January 22, 2015

Subject: **Umetco Minerals Corporation, Gas Hills, Wyoming, Site
Groundwater Evaluation and License Amendment Request**

Reference: **Radioactive Materials License SUA-648; Docket No. 40-0299**

**Western Flow Regime Groundwater Evaluation
For
Gas Hills, Wyoming**

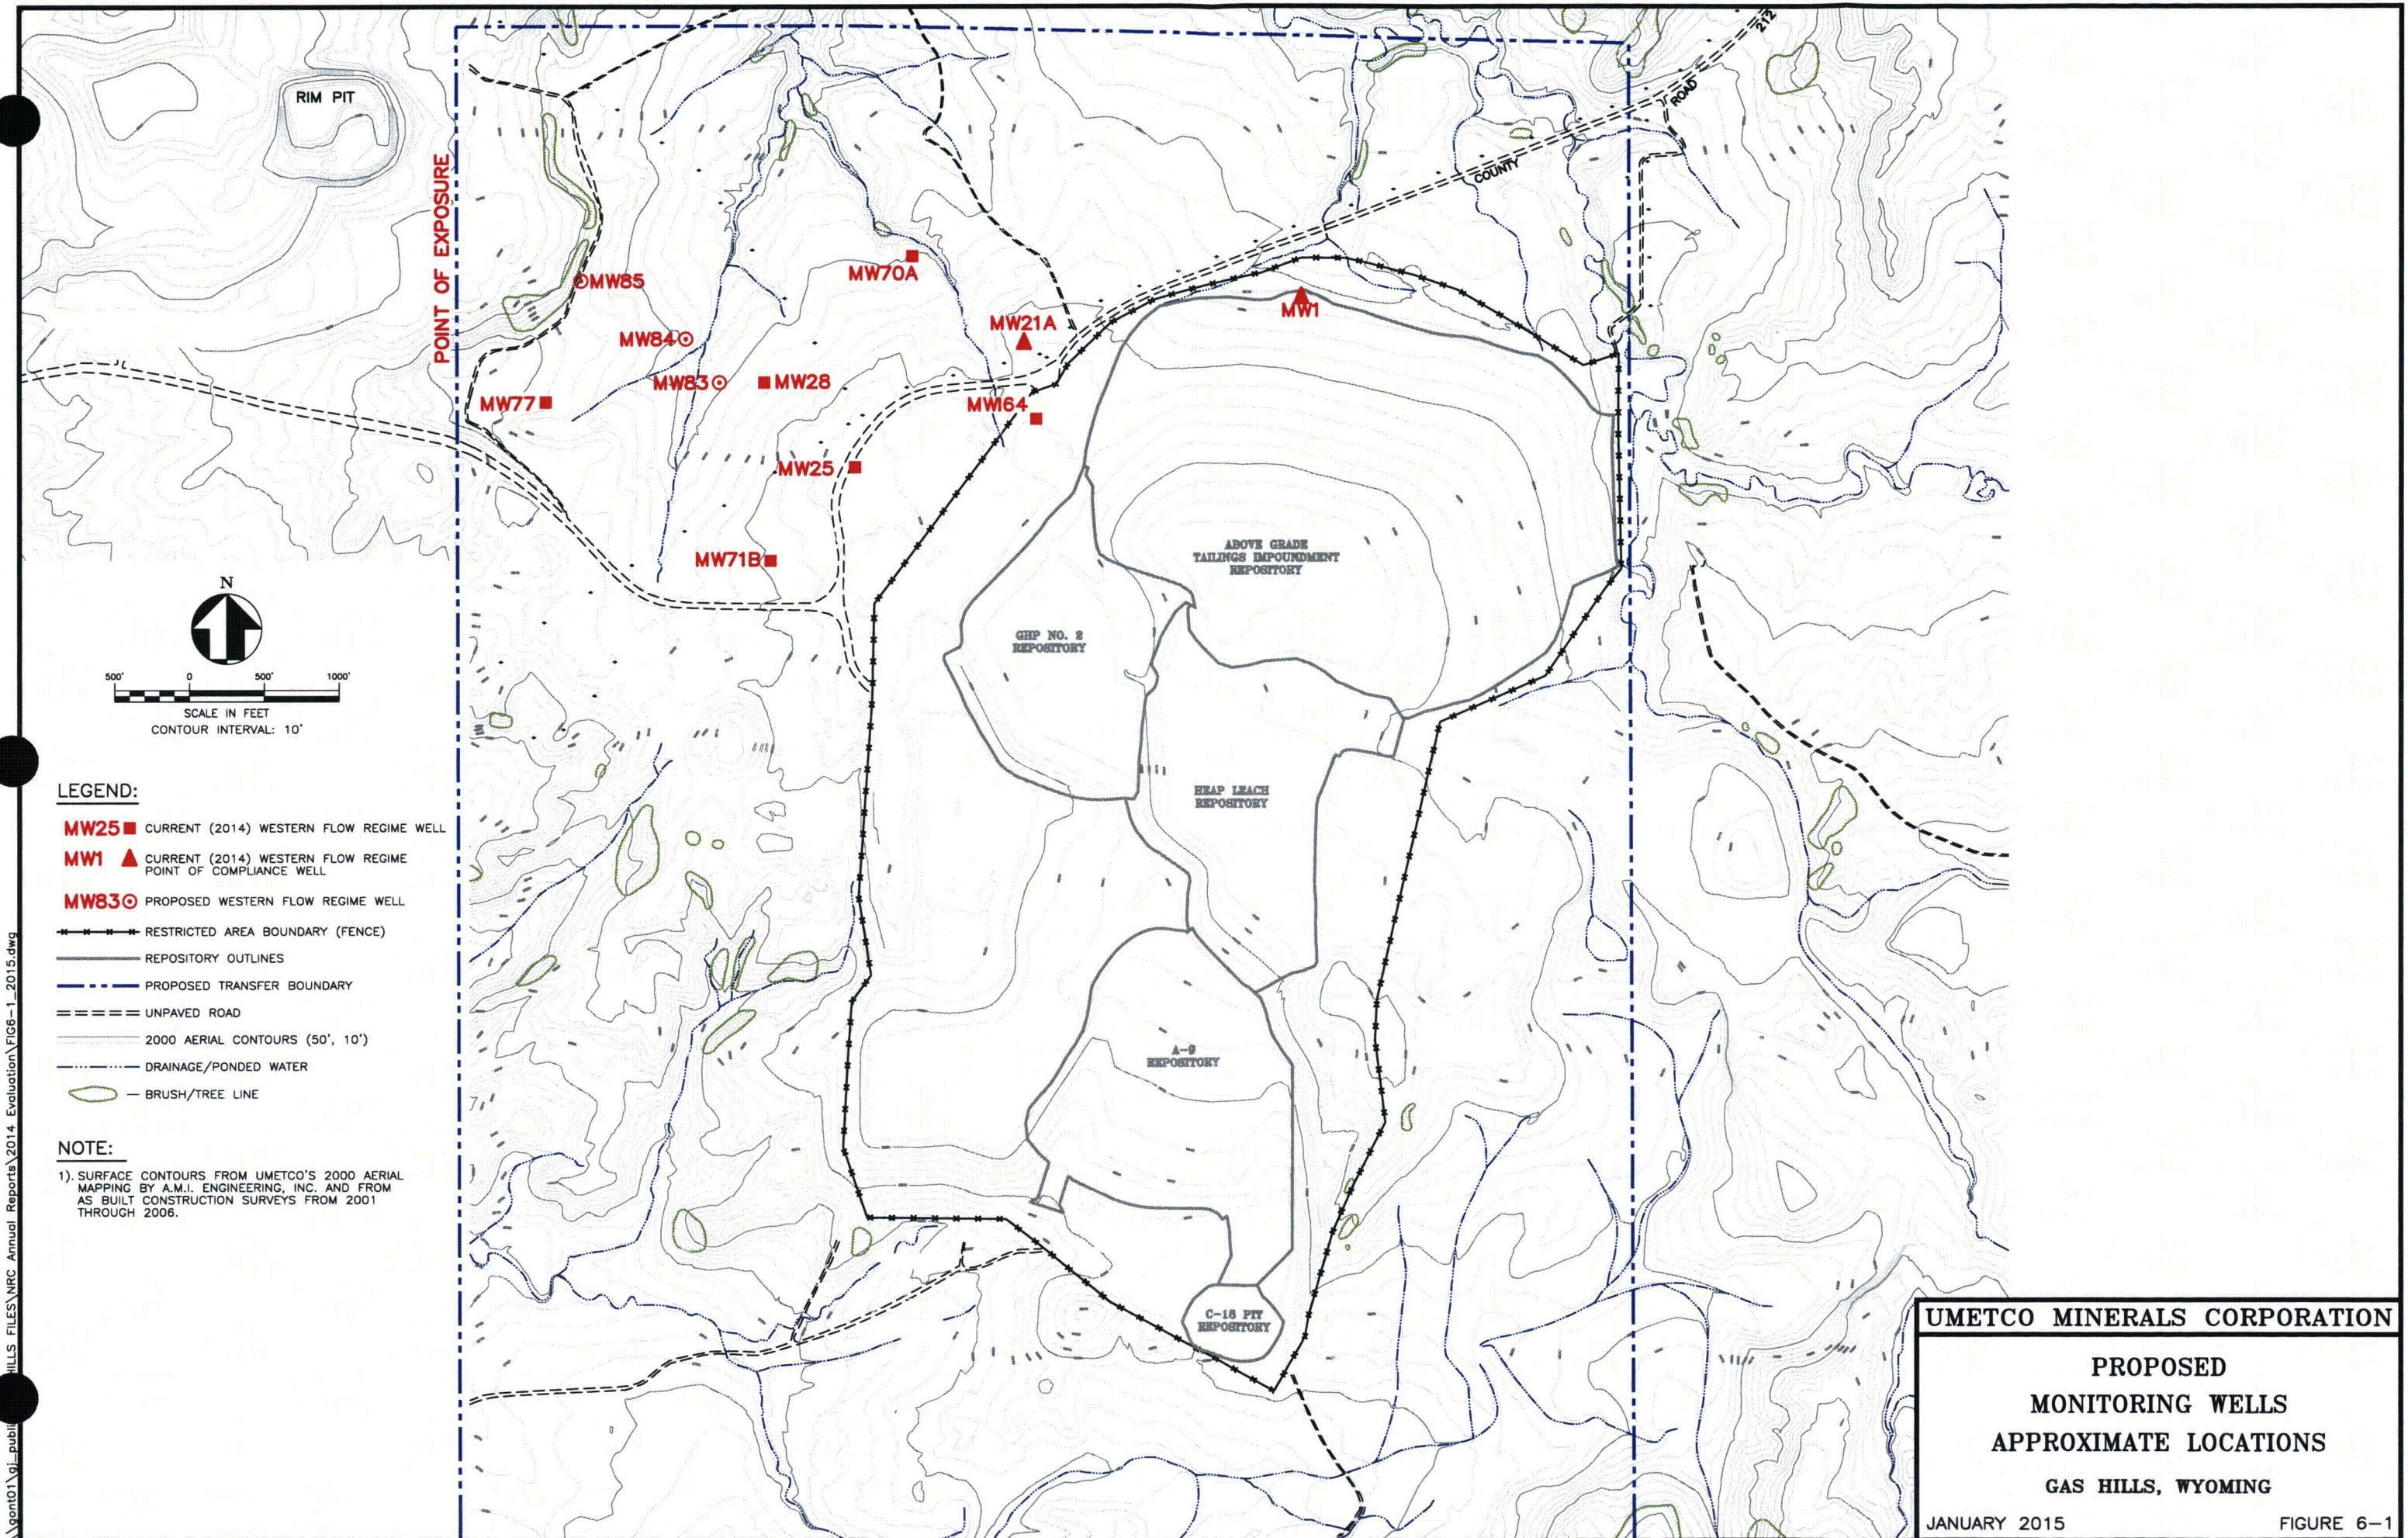
Umetco proposes to install three additional WFR monitoring wells to evaluate radium-226+228 attenuation upgradient of the POE. Proposed locations for the new monitoring wells are shown on Figure 6-1. These locations are only approximate and may need to be adjusted based on field conditions or access limitations.

Well Name	Well Location	Estimated Depth	Objective for New Well
MW83	300 feet west of MW28	240 feet	Well is intended to intercept peak radium-226+228 activities from upgradient within one year of installation. Data from the well will be used to evaluate radium attenuation along the groundwater flow path.
MW84	600 feet northwest of MW28	230 feet	Well will be used to refine the groundwater flow direction and provide a second point for evaluating radium-226+228 attenuation.
MW85	1400 feet northwest of MW28	270 feet	Well is intended to intercept the leading edge of sulfate-impacted groundwater from the AGTI, and will provide an early indication of downgradient contaminant movement.

These three well locations were selected based on an estimated groundwater seepage velocity of 0.29 ft/day. By the time the new wells are installed in the summer of 2015, two years will have elapsed since peak radium-226+228 activities arrived at MW28. In those two years, the radium plume will have migrated slightly over 200 feet downgradient. Thus, the plume should begin to appear at proposed well MW83 within one year after the well is installed. MW83 will consequently provide a valuable data point for assessing radium attenuation along the groundwater flow path between MW28 and downgradient well MW77.

Proposed well MW84 would provide a second data point for assessing radium-226+228 attenuation that will be especially useful if the radium plume is migrating faster than expected. By positioning the well slightly to the northwest, MW84 could also be used to refine the groundwater flow direction. Finally, the location of proposed well MW85 was selected to intercept the leading edge of sulfate impacted groundwater from the AGTI, which likely occurs

MONITORING LOCATIONS
GROUNDWATER MONITORING PLAN

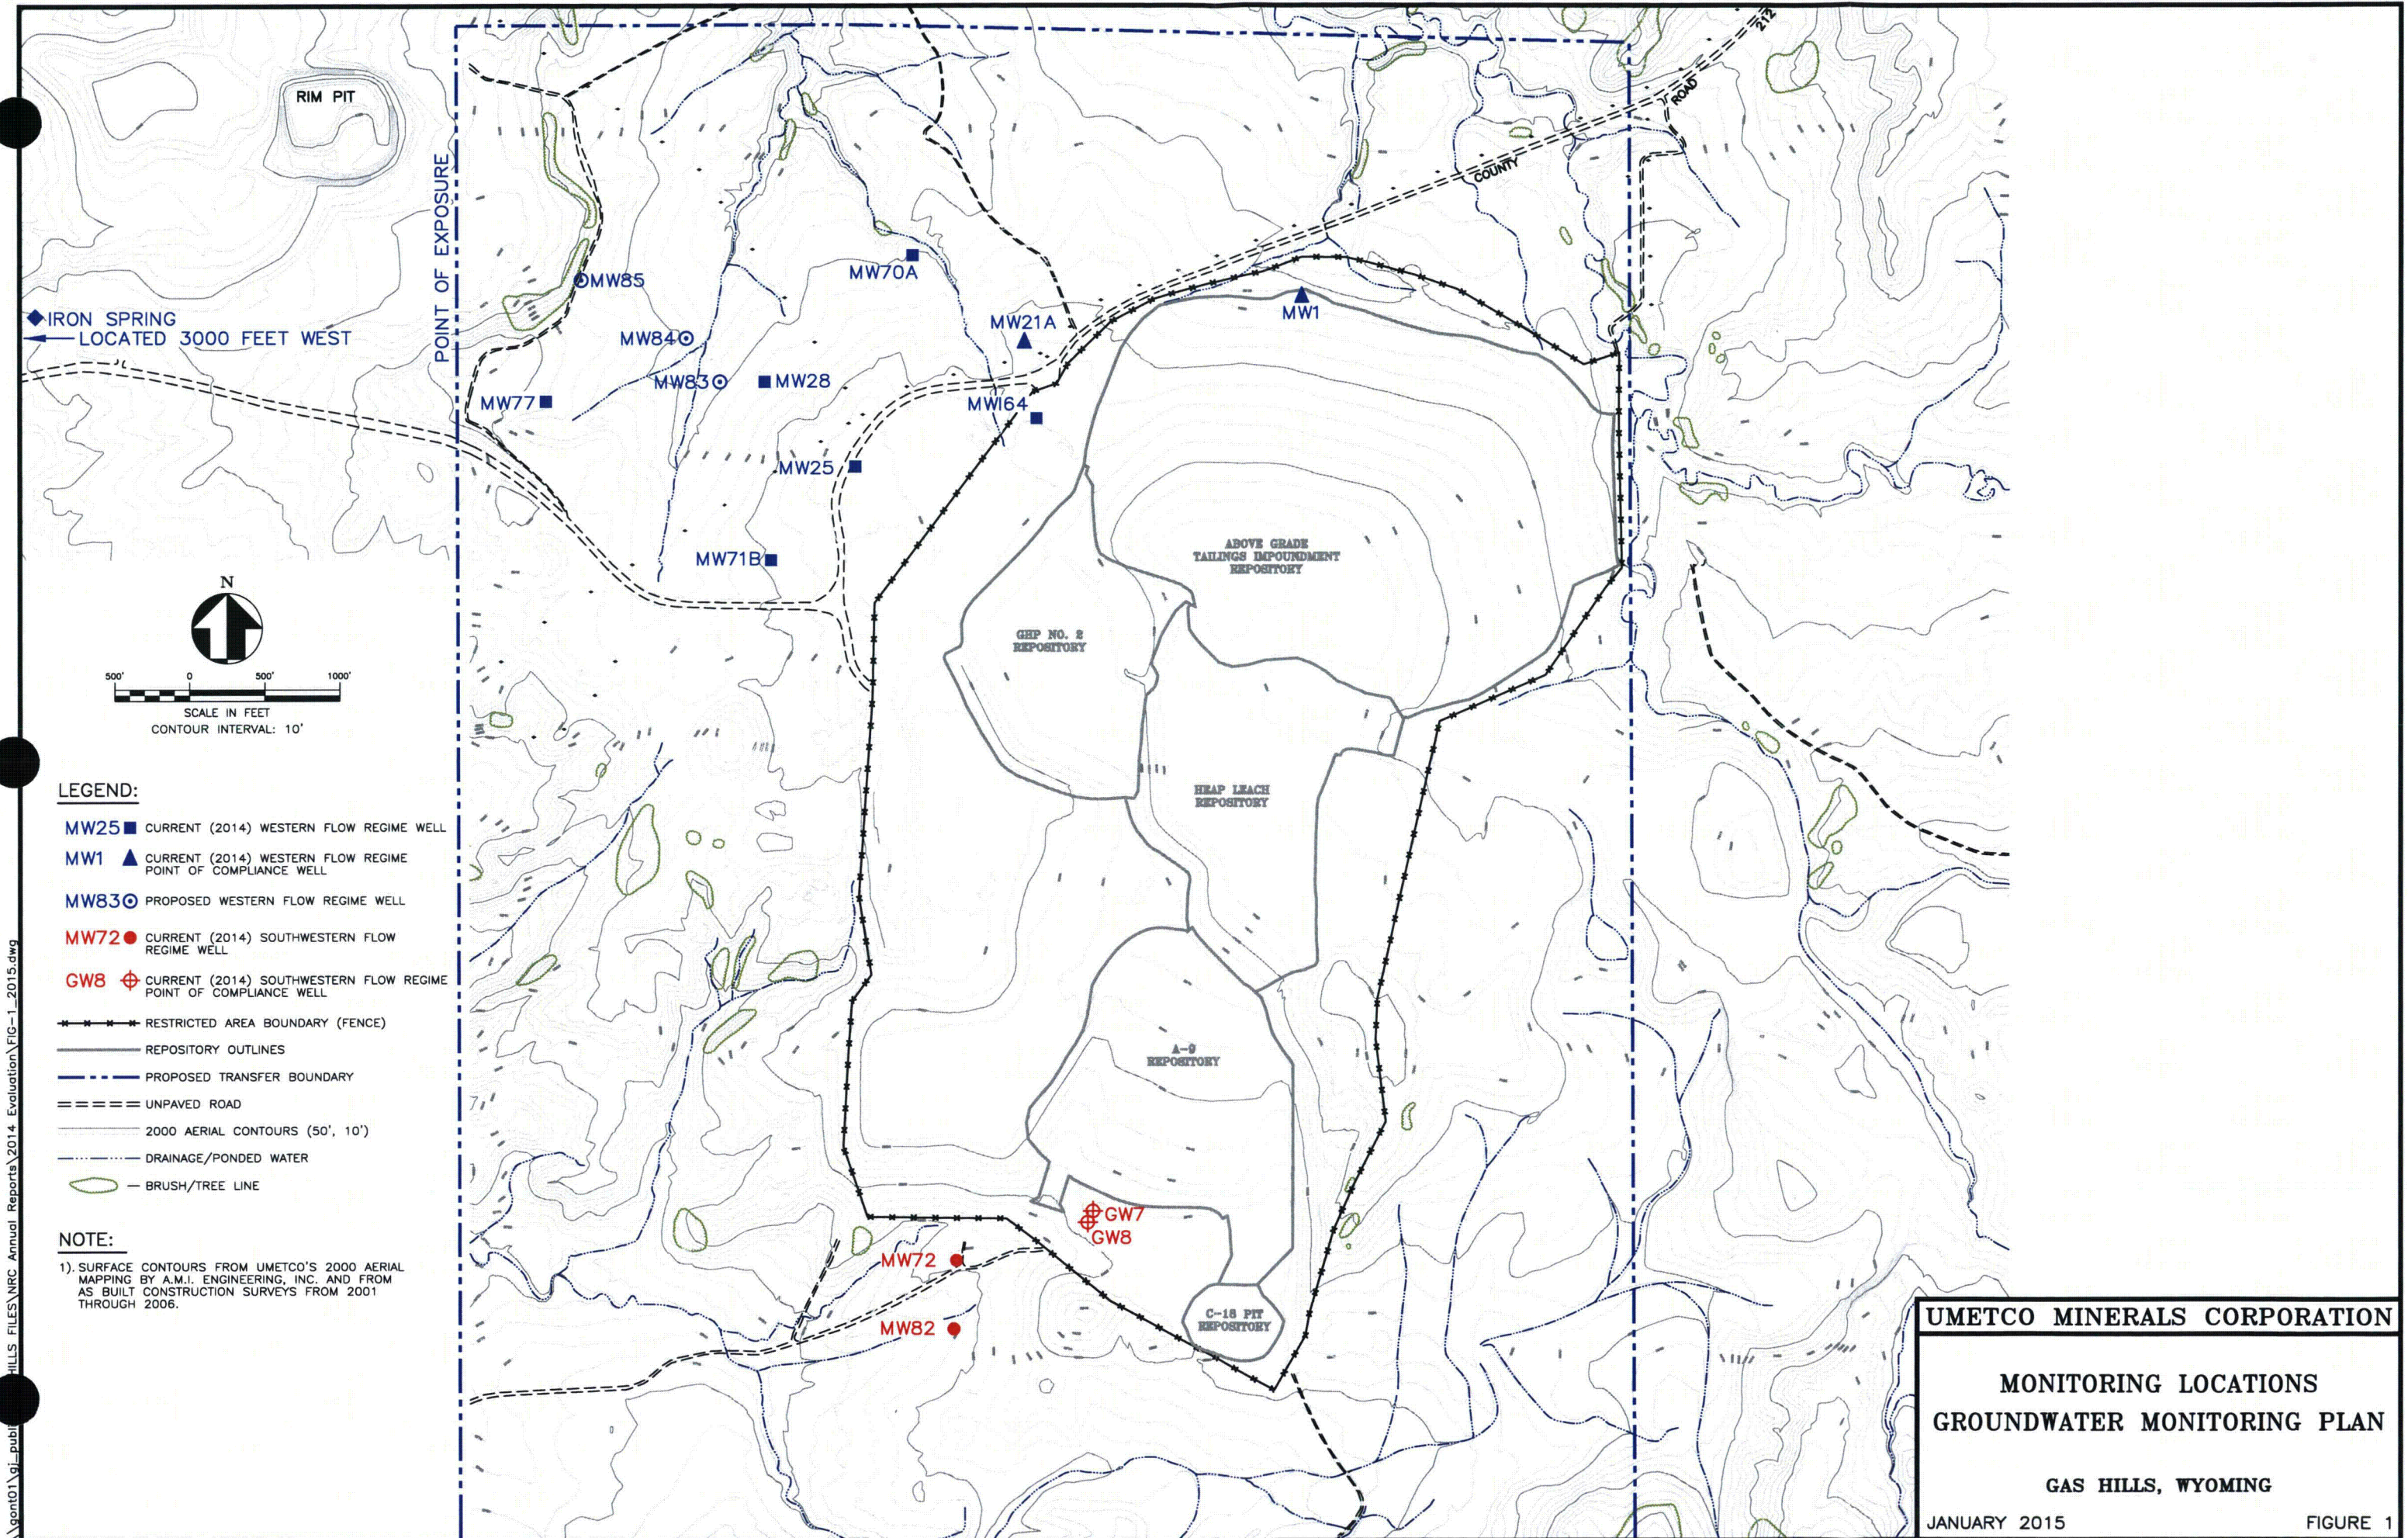
Table 1 lists the POC and non-POC monitoring locations and details their corresponding monitoring requirements. Groundwater monitoring locations are shown on Figure 1 for both the Western and Southwestern flow regimes.

<u>MW84</u>	<u>This well is located 600 feet northwest of MW28. This well will be used to refine the groundwater flow direction and provide a second point for evaluating radium-226+228 attenuation.</u>
<u>MW85</u>	<u>This well is located 1400 feet northwest of MW28. This well is intended to intercept the leading edge of sulfate-impacted groundwater from the AGTI, and will provide an early indication of downgradient contaminant movement.</u>
